PROJECT: UHS P Decatur S. Elkhorn  
(Project in CNLV for CLV Concurrence)

| <b>CITY OF LAS VEGAS<br/>INTER-OFFICE MEMORANDUM</b>                                                                  |                                         | <b>DATE:</b><br>August 26, 2020                                                                   |
| <b>SUBJECT:</b><br>Drainage Study for:<br><b>UHS @ Decatur &amp; Elkhorn</b><br>(Project in CNLV for CLV Concurrence) |                                         | <b>COPIES TO:</b><br>Rietz Consulting, Inc.                                                       |

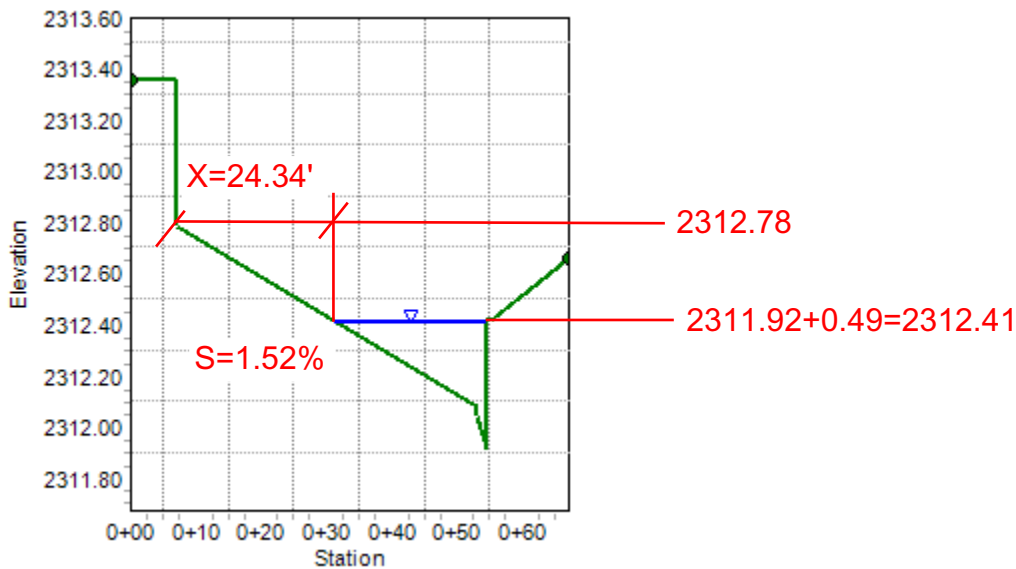
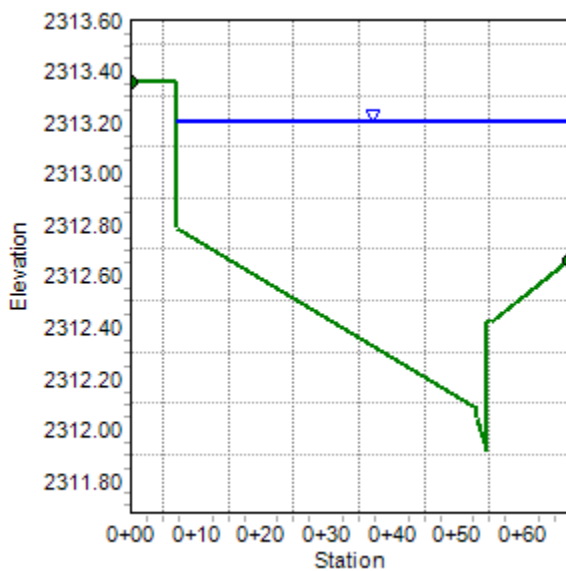
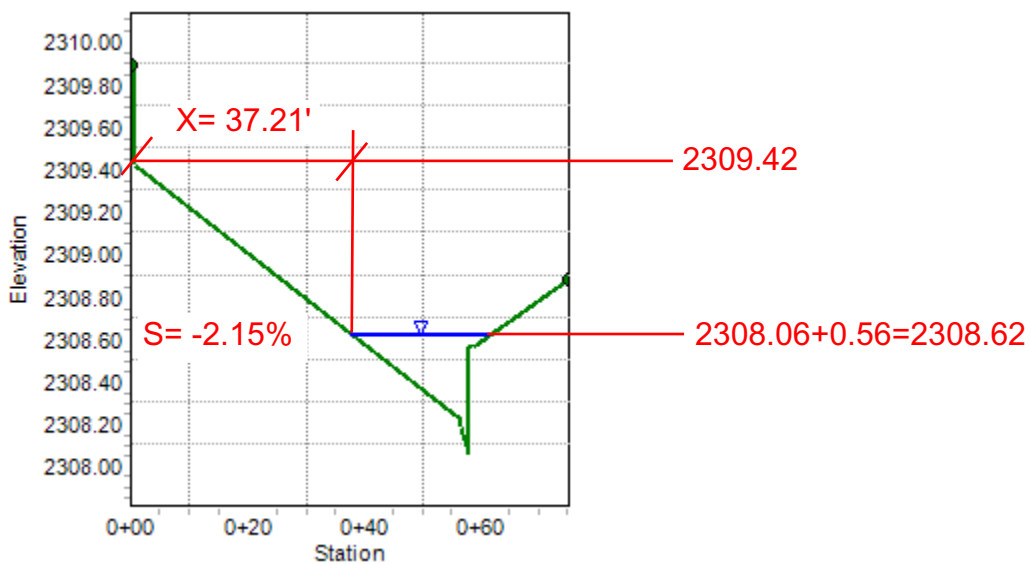
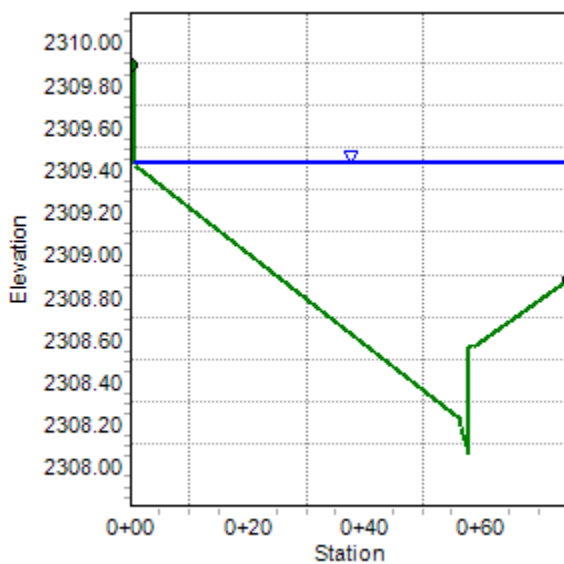
- 10. The Street capacity analysis does not appear to account for the requirement that the plant mix bituminous pavement shall be finished to a height of 3/8 inches to 5/8 inches above the lip of gutters and valley gutters. Included the input data and account for the finished height of plant mix bituminous pavement (0.04 feet) above the lip of gutter in the analysis. The cross slope for Decatur Boulevard in the analysis is 1.75% and the cross slope for Elkhorn road is 2.25%. Are these the surveyed cross slope at the section locations? Please review and revise accordingly.**

- 11. For 80-feet wide and greater streets, the actual dry lane determination must be shown on the q10 street capacity calculations. Please provide the dry lane calculations for Decatur Boulevard and Elkhorn Road. Please review and revise accordingly.**

Response: Analyzed cross sections are taken from site specific topographic information. A half inch vertical elevation difference has been added to the lip of offsite flow sections.

Response: Noted. Dry lane calculations have been revised accordingly.

Response: The velocity calculated in updated sections "A" and "B" in Decatur Boulevard and Elkhorn Road is less than 5 fps.

SHEET  
**C4**  
4 OF 6 SHEETS

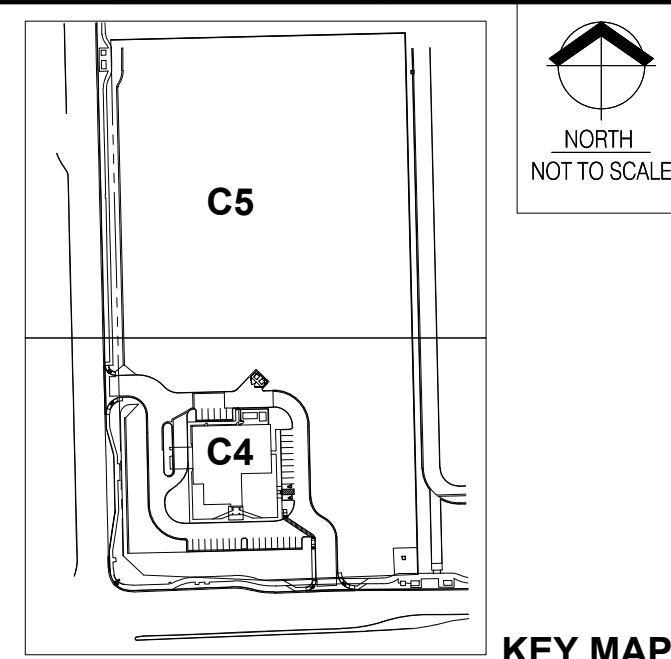
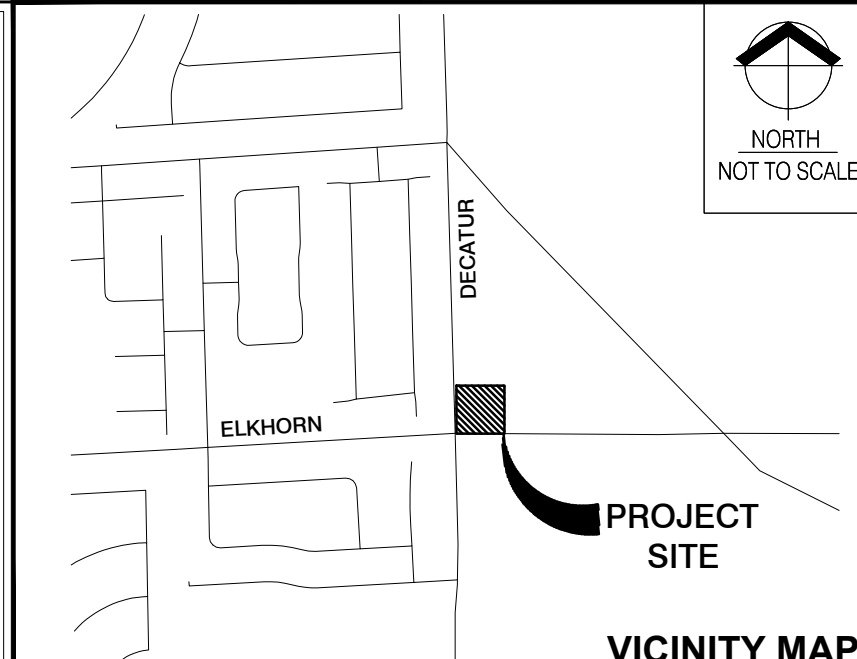
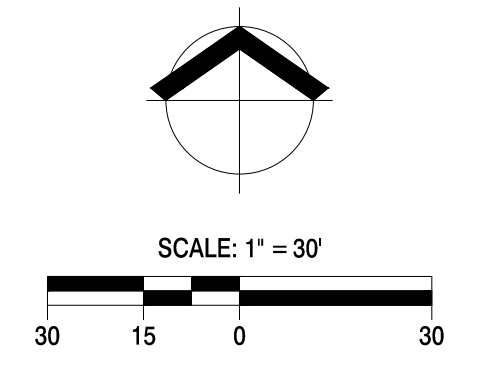
**20. On the Detail Sheet, Sheet C4, where the term varies is utilized, provide a minimum and maximum value. Please review and revise accordingly.**

**21. On the Detail Sheet, Sheet C4, details No. 1 through No. 4 have a building finish floor elevation of 2614.52. The finish floor elevation on the grading plan is 2313.80. Please review and revise accordingly.**

**22. On the Detail Sheet, Sheet C4, Blow up 3, it appears the curb transition and the 0-inch "A" curb are mislabeled with the incorrect construction call out. Please review and revise accordingly.**

Response: Noted. The Detail Sheet C4 has been revised and included in this submittal.

Response: Noted. The Detail Sheet C4 has been revised and included in this submittal.

Response: Noted. The Detail Sheet C4 has been revised and included in this submittal.

**C3**  
SHEET **3** OF **6** SHEETS

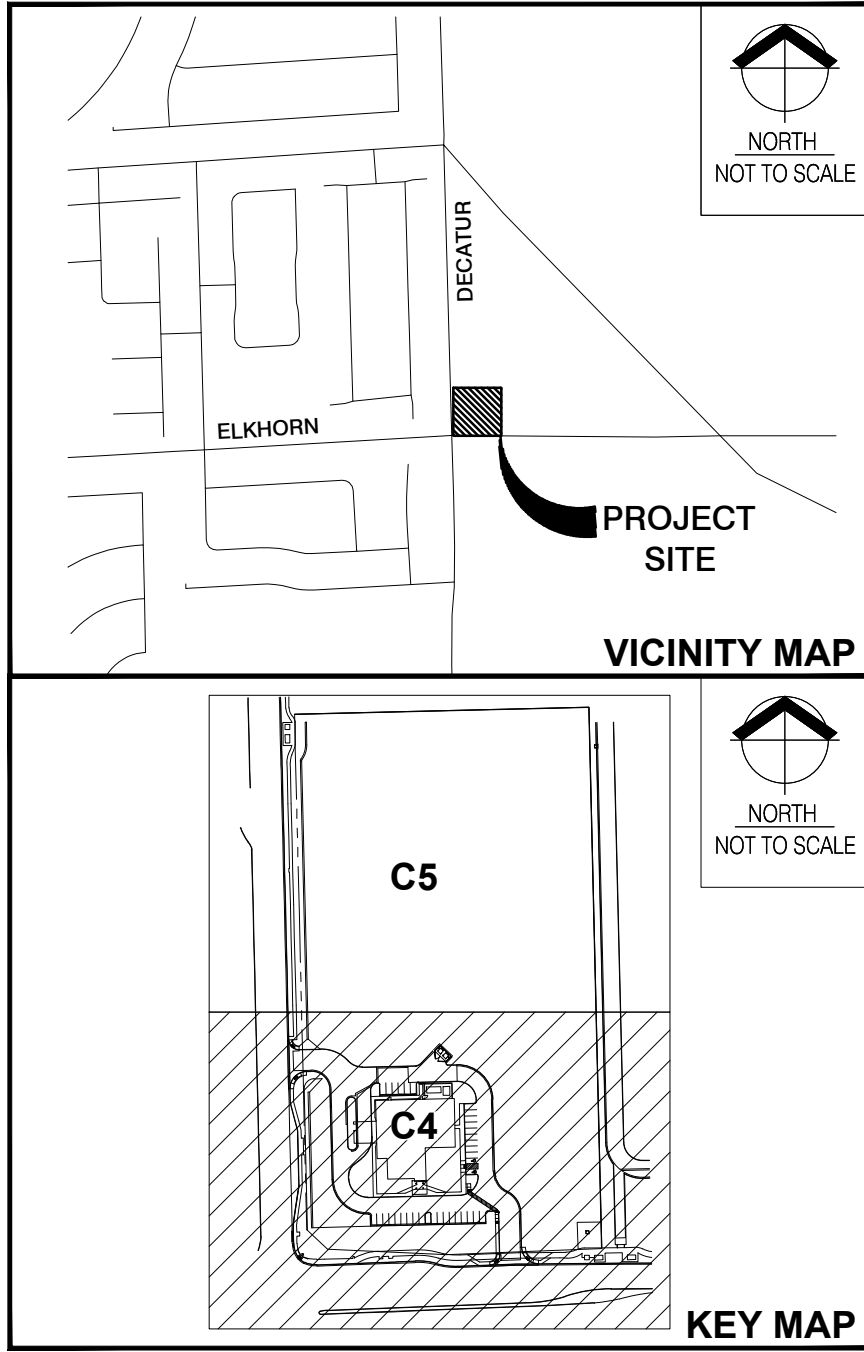
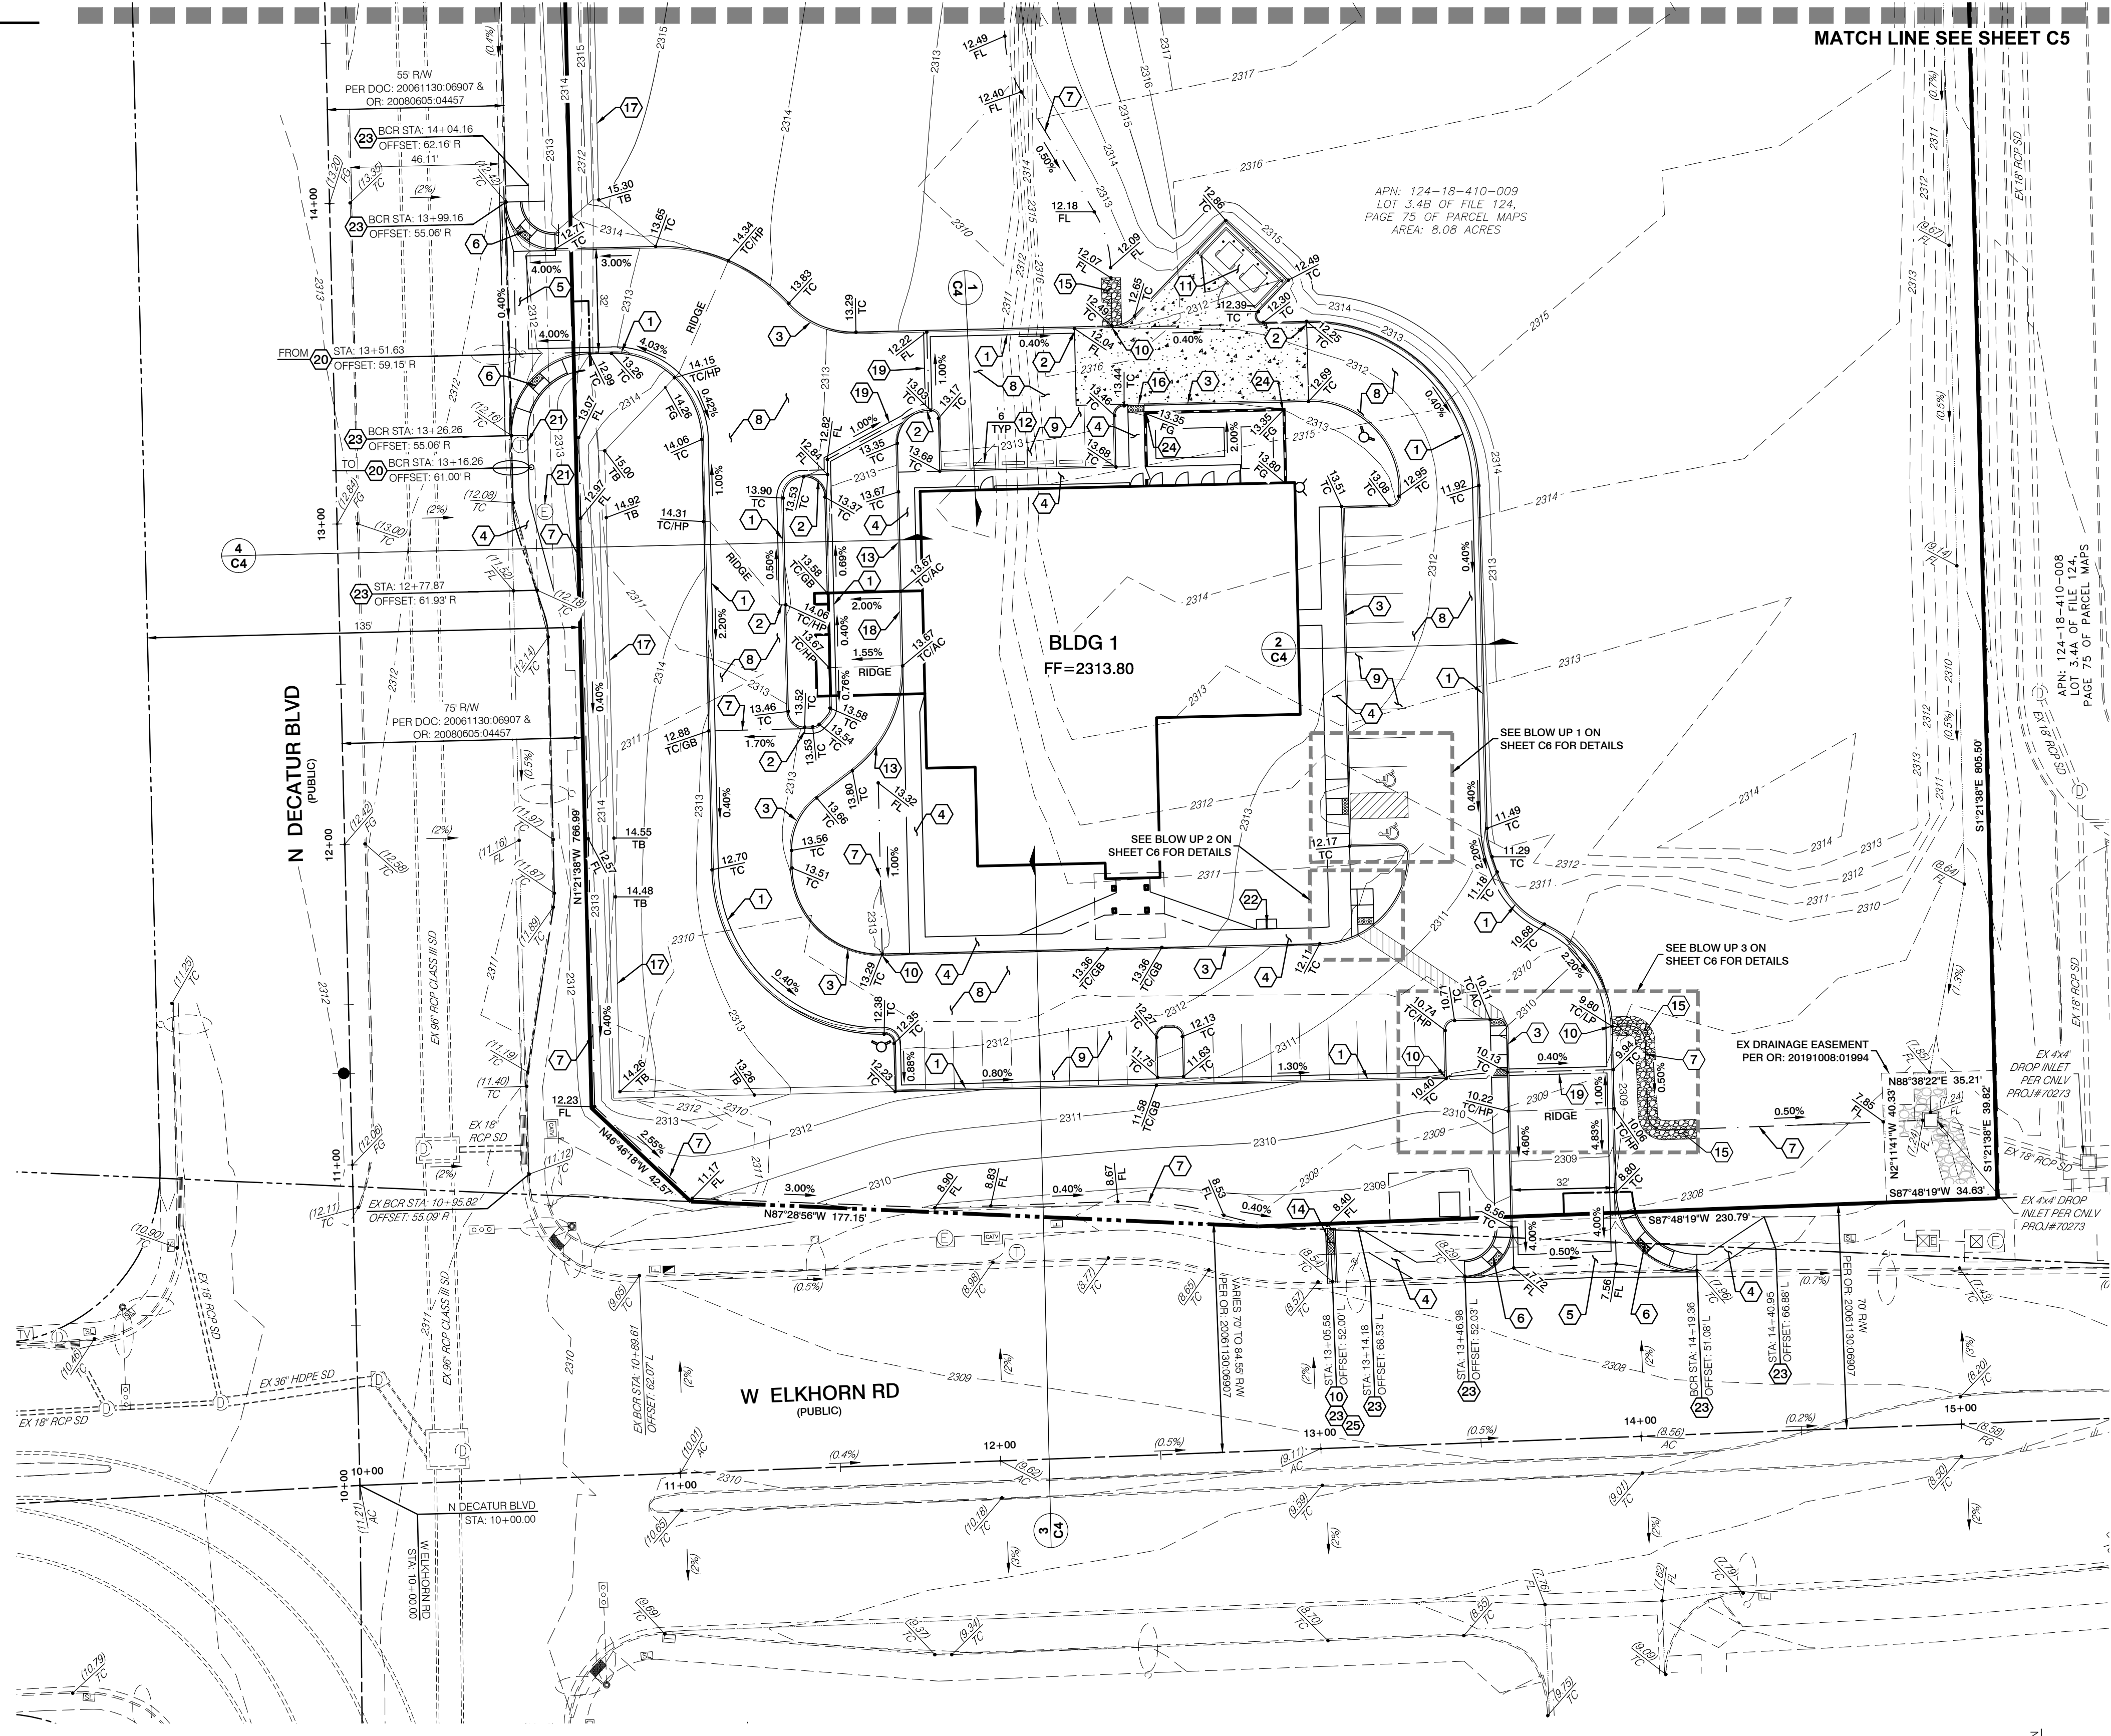
- 12. For Commercial and industrial developments, landscape areas are not allowed to sheet flow over the sidewalk. On Sheet C3, provide flow lines with grades and sidewalk underdrains for landscape areas draining to the street along the West Elkhorn Road frontage between Decatur Boulevard and the project driveway.**

**15. In general, on the grading plan, provide proposed spot elevations in sufficient detail to exhibit intended drainage patterns at curb cuts and sidewalks underdrains, and flow lines in commercial driveways.**

**16. There appears to be existing street lights that require relocation in the driveway approaches on Decatur Boulevard and Elkhorn Road that are labeled with the incorrect construction note (Note No. 25 instead of Note No. 26). Please review and revise accordingly.**

**17. Construction Notes No.'s 11, 18, 23, 24, 25 and 26 are not called out on the grading plan and/or the detail sheet.**

**18. Show existing 4' x 4' drop inlet and storm drain in the existing storm drain easement.**

**19. On the Grading Plan, Sheet C3, at the driveway approach on Elkhorn Road, the elevation at the highpoint line on the west side of the approach is labeled TC/LP. It does not appear to be a low point at this location. Please review and revise accordingly.**

Response: A flow line between the property and the sidewalk has been added and designed to discharge the flow on West Elkhorn Road through a proposed sidewalk under drain. Please see revised and updated Grading Plan C3 included in this submittal.

Response: Noted. The Grading Plan C3 has been revised and included in this submittal.

Response: Noted. The Grading Plan C3 has been revised and included in this submittal.

Response: Noted. The Grading Plan C3 has been revised and included in this submittal.

Response: Noted. The Grading Plan C3 has been revised and included in this submittal.

Response: Noted. The Grading Plan C3 has been revised and included in this submittal.
